**VA24-01; REZ24-01; REZ24-03; & PUD24-03**                      **145 S. Morristown Pike** McNeely Law LLP as applicant; William Eric Group, LLC as owner, request a zoning recommendation of “RL” Residential Low Density District, “PUD” Planned Unit Development District, & “PK” Park District Zoning Designations for 169.513 acres +/- collectively upon Greenfield City Council annexation approval. The Property is not yet zoned.

### **PUD24-02 – Planned Unit Development Zoning Proposal**

### **PUD Plan**

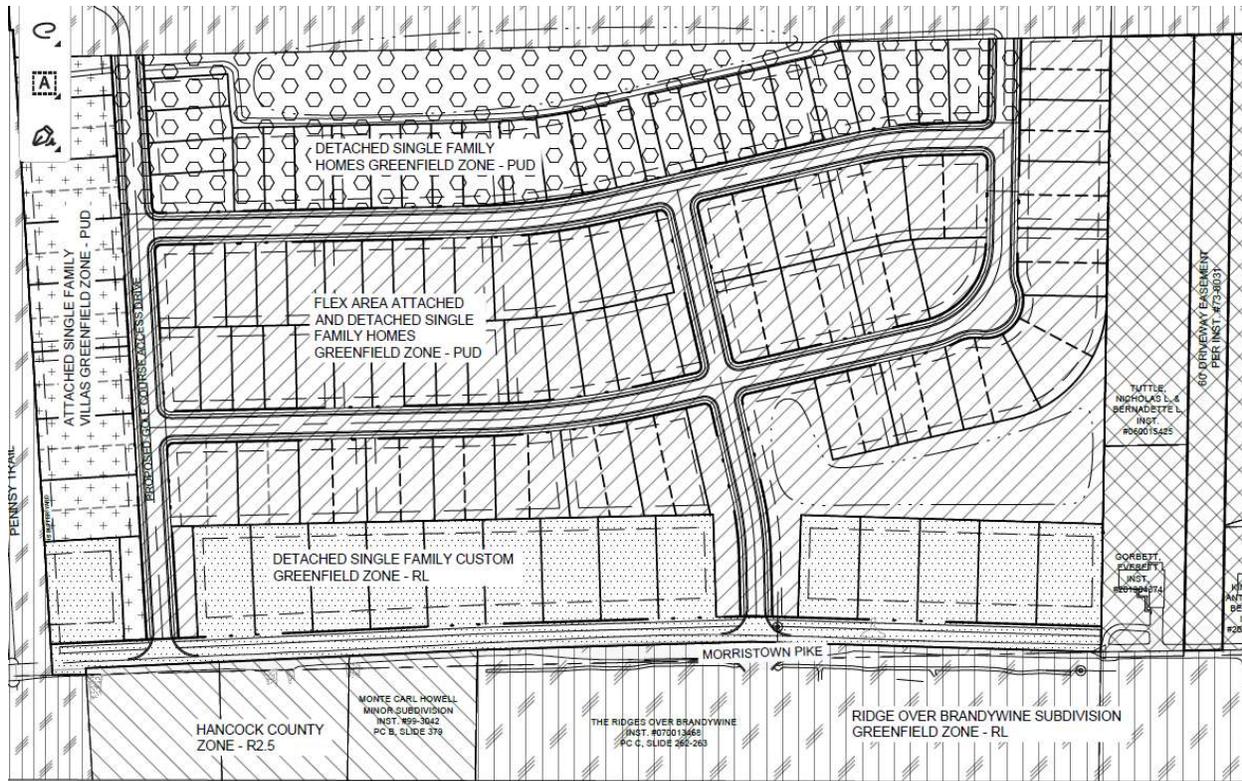
Exhibit “EX3” shows designated sections within the PUD for 14 Paired Villas along the Pennsy Trail and 26 Single Family Detached Homes adjoining the golf course and 76 “Flex” areas where the needs of the market will determine if each section will be developed as paired or detached units. These Flex areas have 4 sections, and all units in each section are proposed to be of the same type, Paired Villas or Single Family Detached.

**Findings:** Staff recommends a revised PUD plan be submitted reducing the density from 3.9 units per acre to 3.6 units per acre based on simple geometry and some basic premises about house siting on a lot. The total number of lots should be reduced to no more than 105. Staff also recommends a minimum 20 foot front setback for all lots. All single family lots need to be 60 feet wide and both the single family and the paired villas all need to provide two car garages.

The need for two car garages is based on the verbally stated price point and the premise that this community is to be a recreationally oriented lifestyle. Two car garages will be needed to accommodate bicycles, golf carts, golf clubs, etc., and hopefully two cars. The average two car garage is 20 feet wide. A typical ranch home as shown in the PUD Statement is 40 to 45 feet wide. This need for storage space increases the need for at least a 20 foot setback on all lots so cars can be parked in the driveway.

The PUD Statement and Plan allows for a 15 foot setback for the primary structure and a “20’ parking space outside of the right of way that does not fully block the garage access.”. Staff requested an explanation or graphic to understand this standard but have not received one. At these lot sizes the HOA covenants should prohibit parking any recreational vehicles on lots outside of a normal driveway and then only for a short period of time such as the time needed to load a camper for a trip. The UDO contemplates 10 foot front setbacks in Residential Urban Districts but this is typically found with homes that provide a traditional style of architecture with a large front porch and rear alley access or a detached garage. This is not the case in this proposal so staff recommends a 20 foot setback for all structures.

### Staff proposed PUD Plan

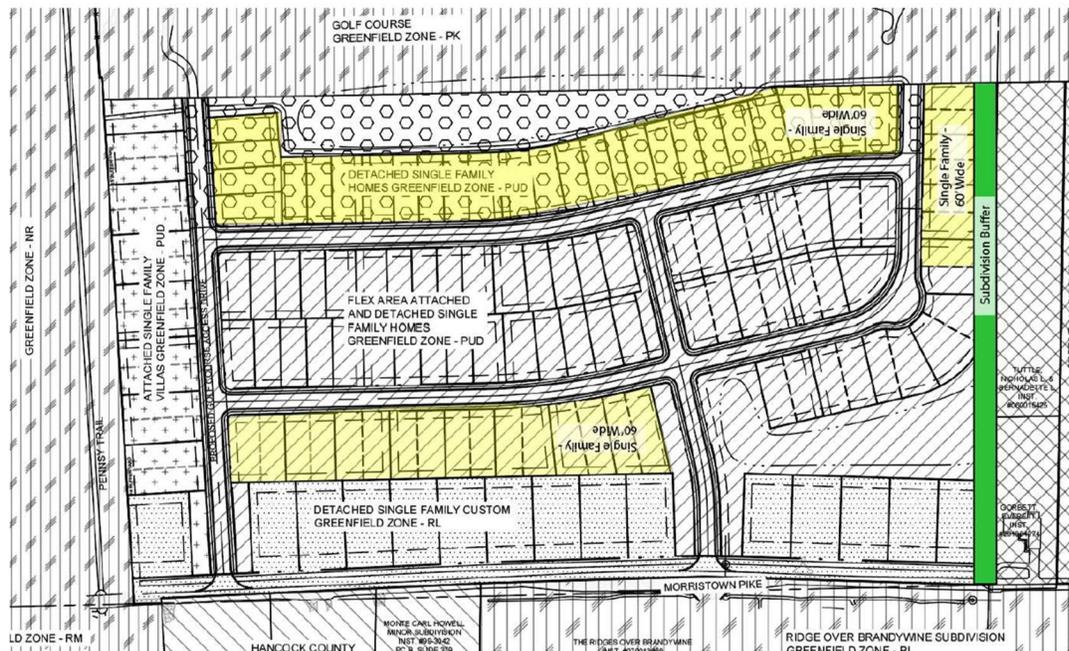
Furthermore, the PUD Plan should be amended to dedicate the lots adjacent to the RL lots as single family lots, being 60 feet wide. The 16 lots adjacent to the RL would then be reduced to 13 single family lots on a revised PUD plan. Similarly, the 26 lots along the golf course would be 60 foot wide single family lots, and reduce the number shown to 17 lots. The lots adjacent to the south perimeter should also be 60 foot wide single family lots reducing the 8 proposed lots to 7 lots. This reduces the maximum # of lots to 102, however, staff also recommends a perimeter yard or buffer of 20 feet be added to the south line. The PUD statement and Plan indicate a perimeter setback of 15 feet on boundaries but this plan is actually showing the proposed rear yard setback and not an additional perimeter buffer. Staff does not feel a buffer yard is required adjacent to the heavily wooded Pennsy Trail. This 20 foot buffer yard to the south could potentially eliminate another 4 lots across the width of the PUD.

Example of Typical Detached Homes on 48' by 130' lots with Facade Depth fluctuating +/- 10' from neighboring home.

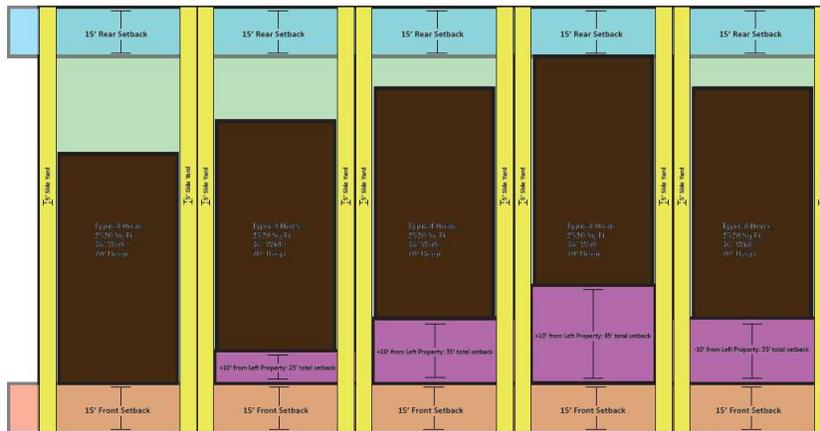
Below is a diagram of home siting and the lot coverage a ranch home would require as proposed. The 45 foot front setback described in the PUD Statement does not provide for useable outdoor space that is typically found in back yards. This commitment has not been well thought out. Staff recommends a curvilinear setback line be established at platting if so desired

to create a pleasing streetscape being between 20 and 30 feet at 5 foot intervals. In the meantime, the PUD should be simplified to provide a 20 foot minimum front setback.

### **PUD Plan**

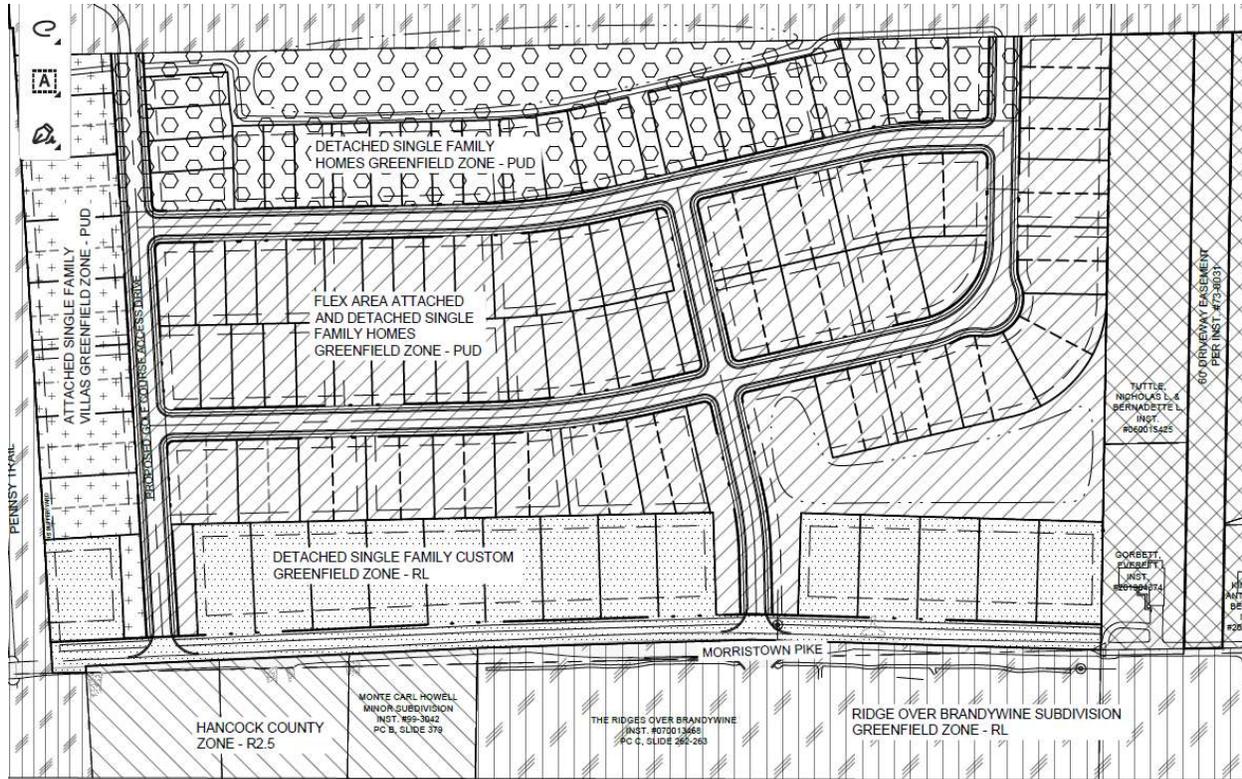
Exhibit “EX3” shows designated sections within the PUD for 14 Paired Villas along the Pennsy Trail and 26 Single Family Detached Homes adjoining the golf course and 76 “Flex” areas where the needs of the market will determine if each section will be developed as paired or detached units. These Flex areas have 4 sections, and all units in each section are proposed to be of the same type, Paired Villas or Single Family Detached.

**Findings:** Staff recommends a revised PUD plan be submitted reducing the density from 3.9 units per acre to 3.6 units per acre based on simple geometry and some basic premises about house siting on a lot. The total number of lots should be reduced to no more than 105. Staff also recommends a minimum 20 foot front setback for all lots. All single family lots need to be 60 feet wide and both the single family and the paired villas all need to provide two car garages.

The need for two car garages is based on the verbally stated price point and the premise that this community is to be a recreationally oriented lifestyle. Two car garages will be needed to accommodate bicycles, golf carts, golf clubs, etc., and hopefully two cars. The average two car garage is 20 feet wide. A typical ranch home as shown in the PUD Statement is 40 to 45 feet wide. This need for storage space increases the need for at least a 20 foot setback on all lots so cars can be parked in the driveway.

The PUD Statement and Plan allows for a 15 foot setback for the primary structure and a “20’ parking space outside of the right of way that does not fully block the garage access.”. Staff requested an explanation or graphic to understand this standard but have not received one. At these lot sizes the HOA covenants should prohibit parking any recreational vehicles on lots outside of a normal driveway and then only for a short period of time such as the time needed to load a camper for a trip. The UDO contemplates 10 foot front setbacks in Residential Urban Districts but this is typically found with homes that provide a traditional style of architecture with a large front porch and rear alley access or a detached garage. This is not the case in this proposal so staff recommends a 20 foot setback for all structures.

### Staff proposed PUD Plan

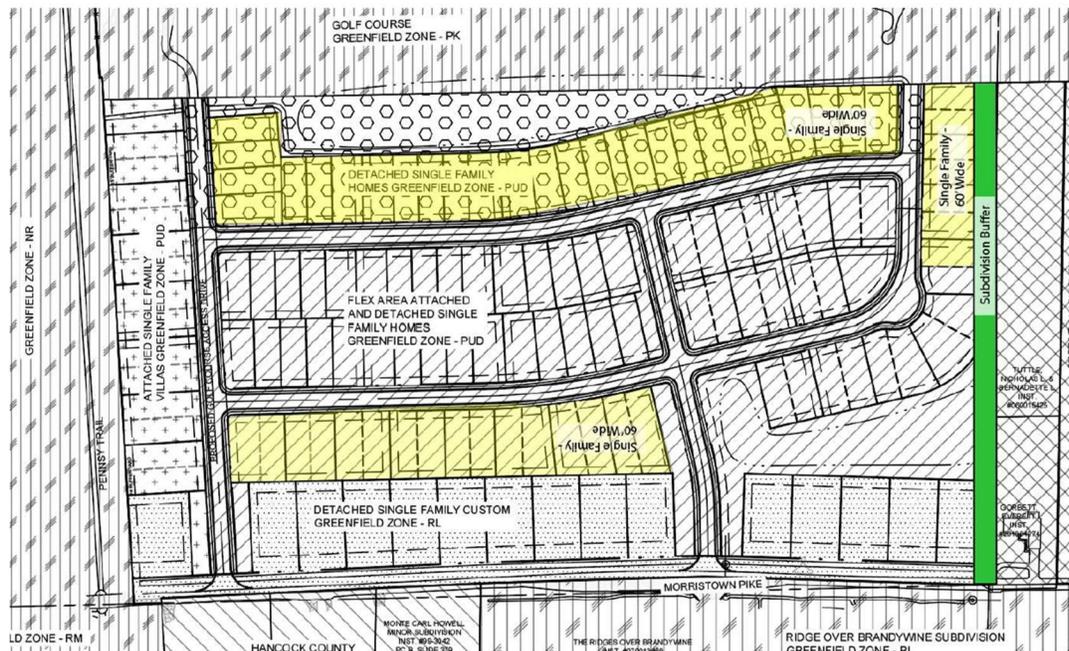
Furthermore, the PUD Plan should be amended to dedicate the lots adjacent to the RL lots as single family lots, being 60 feet wide. The 16 lots adjacent to the RL would then be reduced to 13 single family lots on a revised PUD plan. Similarly, the 26 lots along the golf course would be 60 foot wide single family lots, and reduce the number shown to 17 lots. The lots adjacent to the south perimeter should also be 60 foot wide single family lots reducing the 8 proposed lots to 7 lots. This reduces the maximum # of lots to 102, however, staff also recommends a perimeter yard or buffer of 20 feet be added to the south line. The PUD statement and Plan indicate a perimeter setback of 15 feet on boundaries but this plan is actually showing the proposed rear yard setback and not an additional perimeter buffer. Staff does not feel a buffer yard is required adjacent to the heavily wooded Pennsy Trail. This 20 foot buffer yard to the south could potentially eliminate another 4 lots across the width of the PUD.

Example of Typical Detached Homes on 48' by 130' lots with Facade Depth fluctuating +/- 10' from neighboring home.

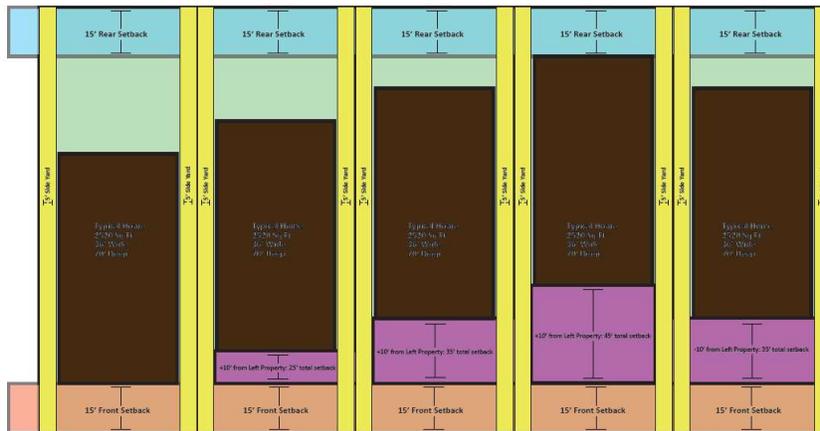
Below is a diagram of home siting and the lot coverage a ranch home would require as proposed. The 45 foot front setback described in the PUD Statement does not provide for useable outdoor space that is typically found in back yards. This commitment has not been well thought out. Staff recommends a curvilinear setback line be established at platting if so desired

to create a pleasing streetscape being between 20 and 30 feet at 5 foot intervals. In the meantime, the PUD should be simplified to provide a 20 foot minimum front setback.
